A G E N D A

Architectural Review Board

March 1, 2016

965 Cloverdale Road

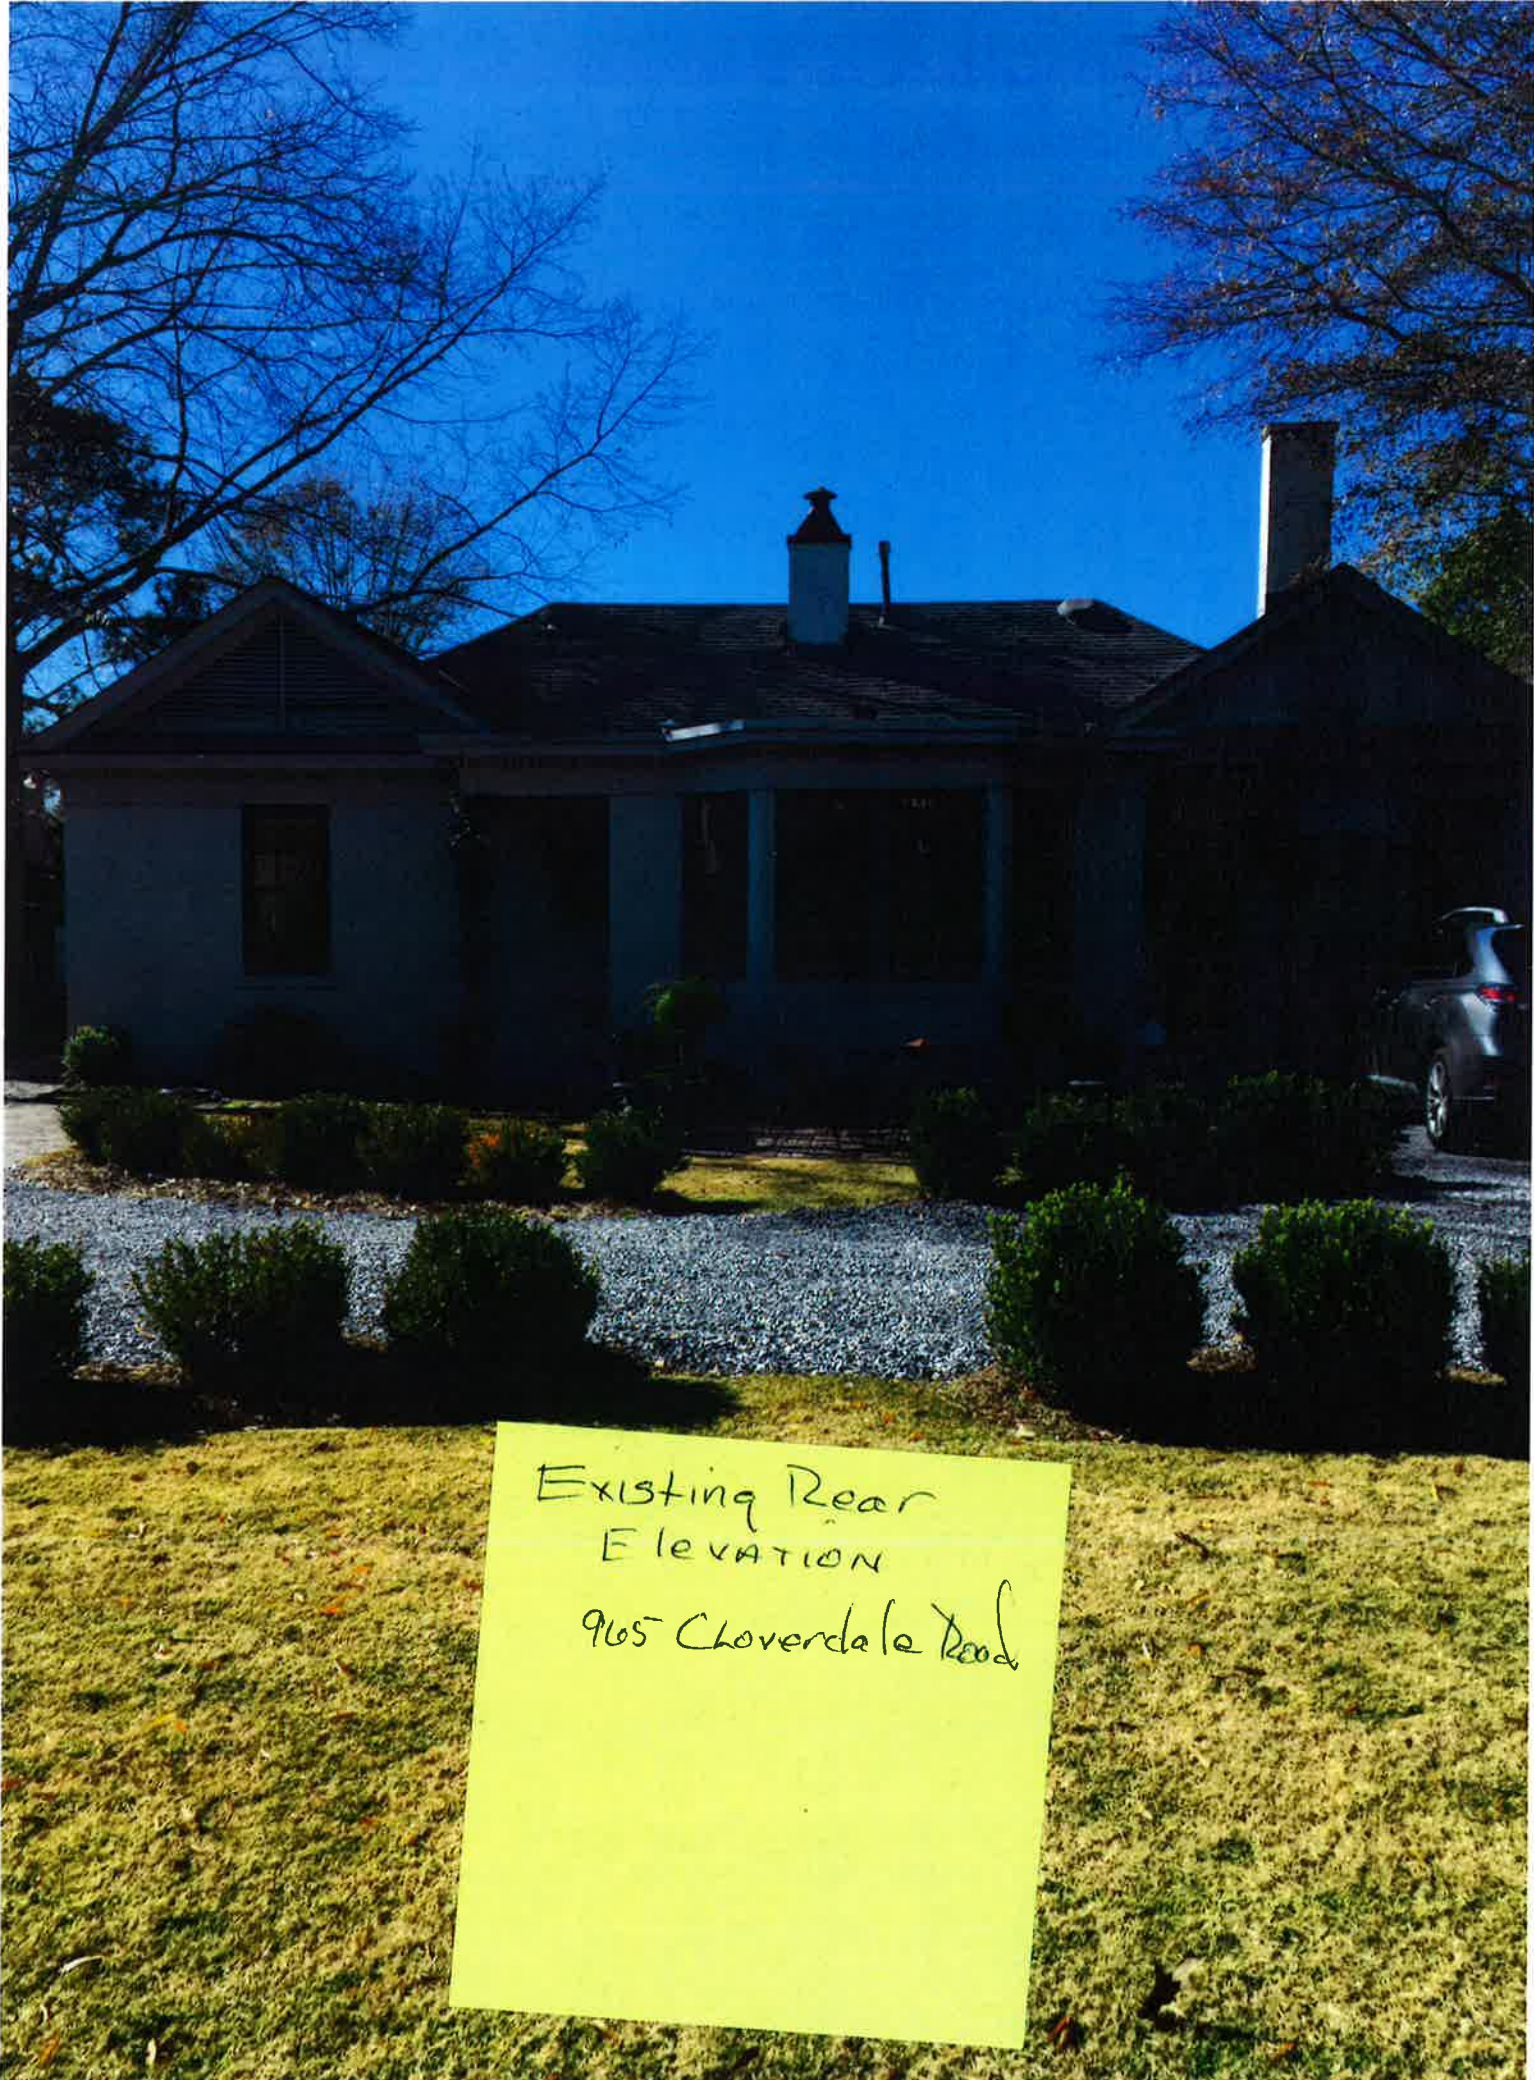
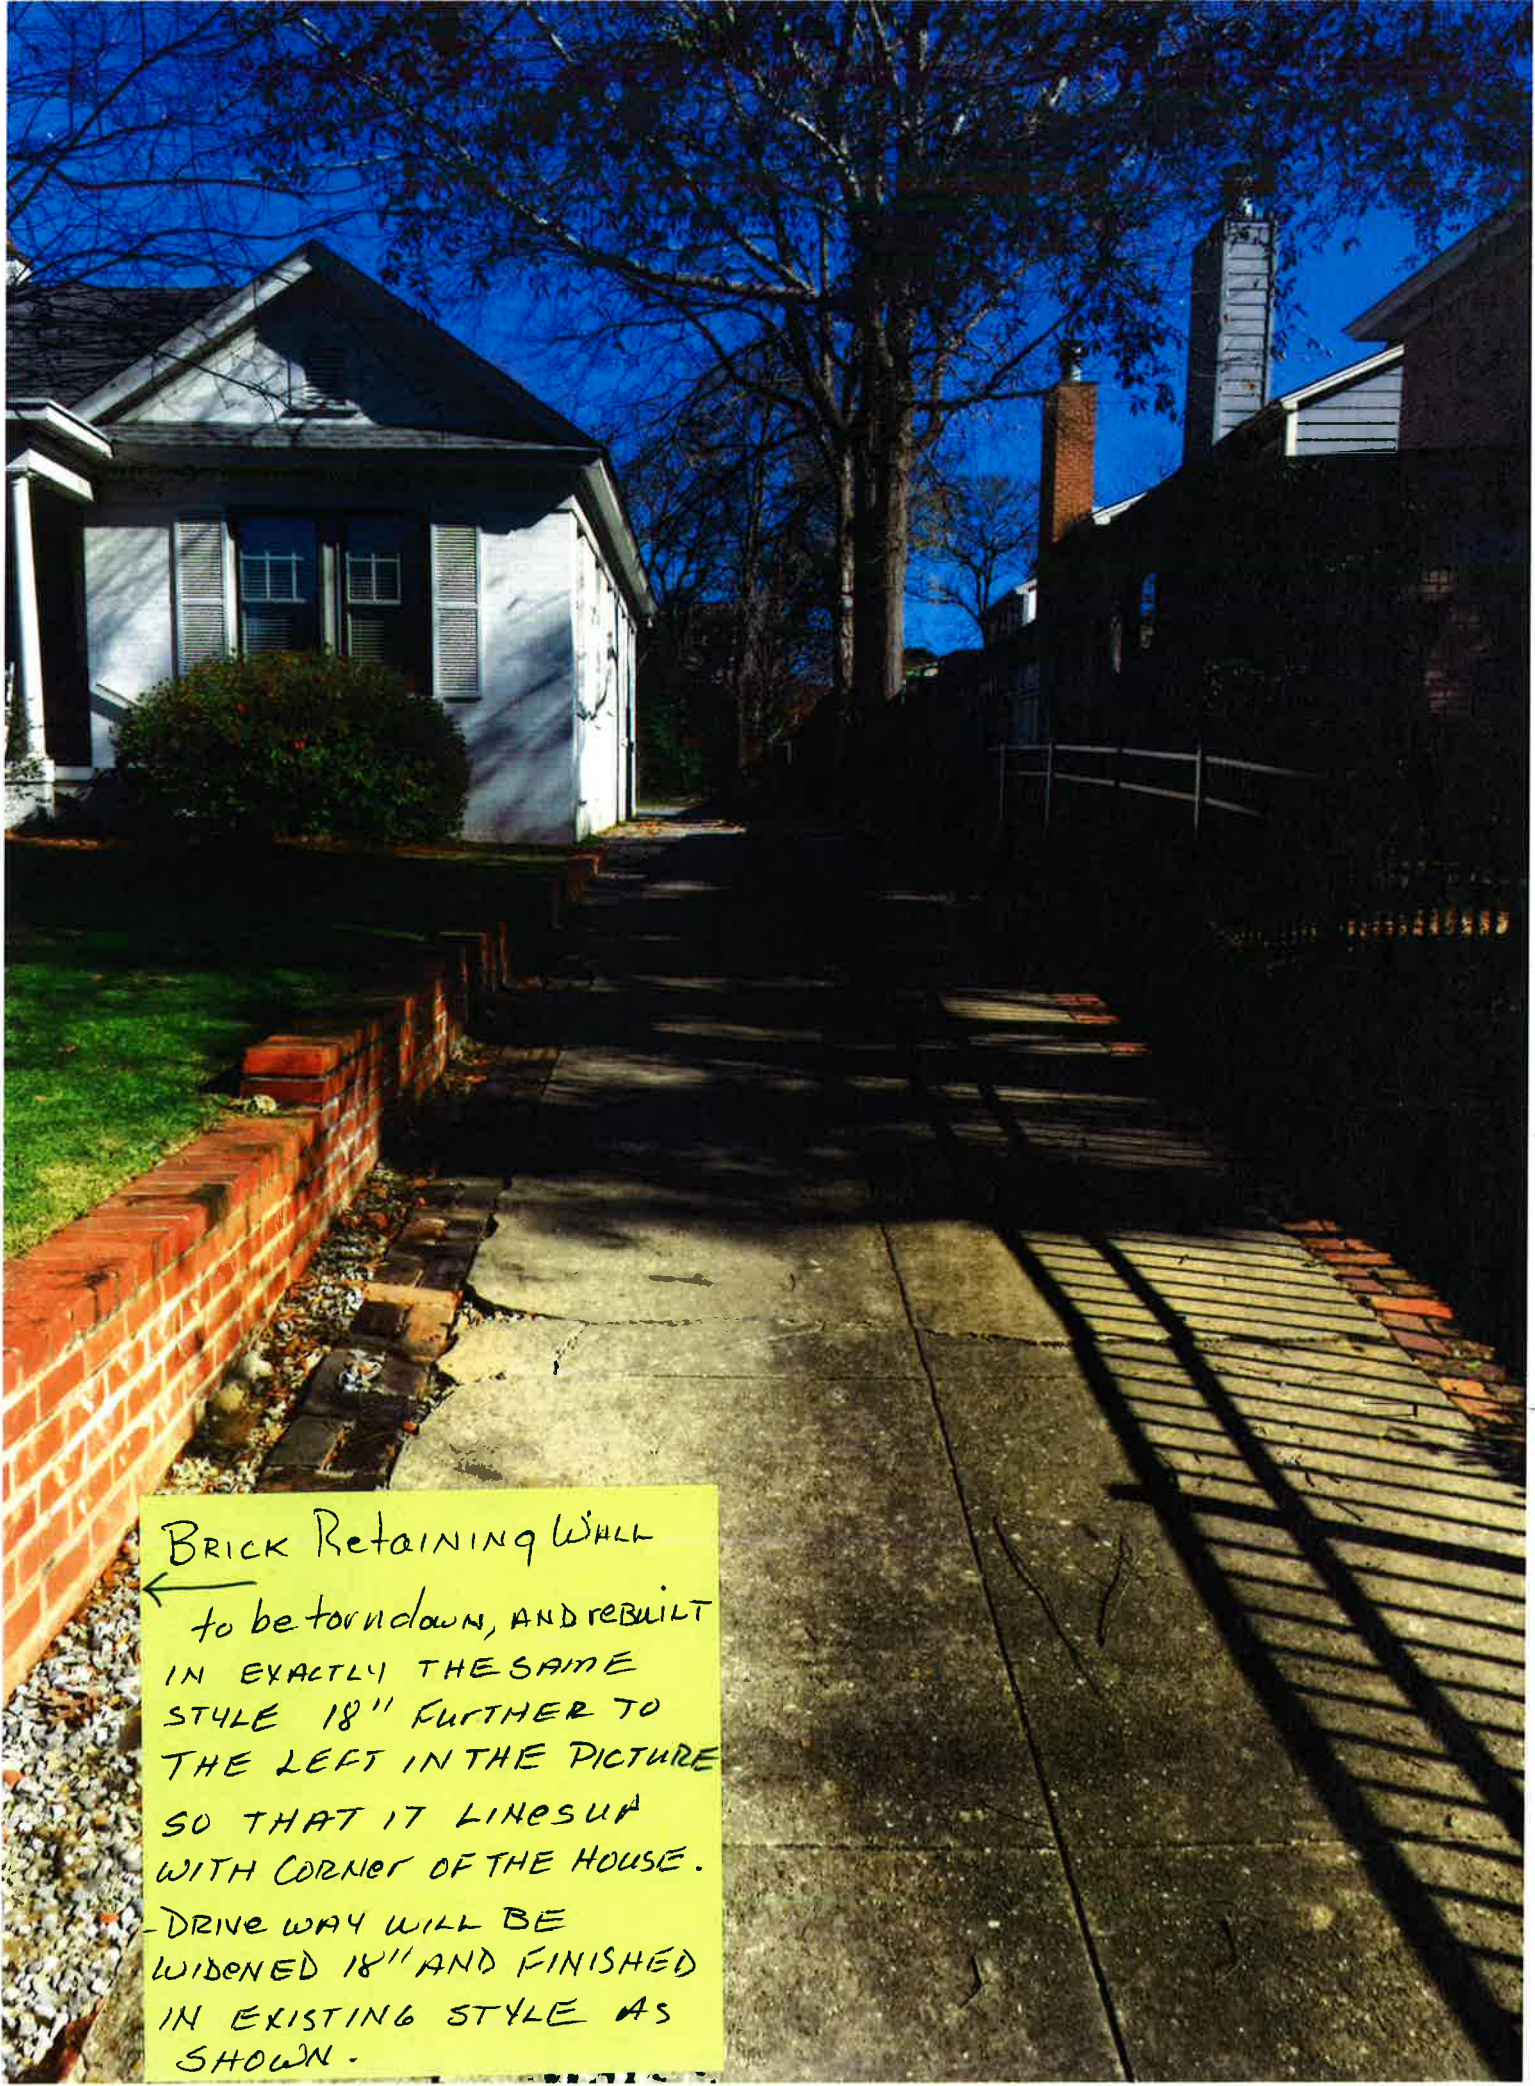
- The Board has previously approved the use of metal roofs on porches and low slopes to help address drainage issues.
- Plans are inserted into the agenda packet separately on 11x17 paper
